REVISED STAFF REPORT

Case #21-09: Site Plan Review

Case #21-10: Special Permit

563 County Street
Map: 58 Lot: 259

Signage

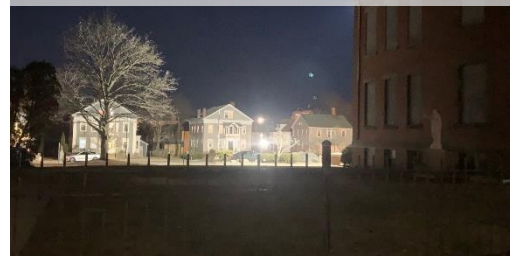
A standard handicapped parking sign is proposed for the handicapped accessible parking space. No other signage is proposed.
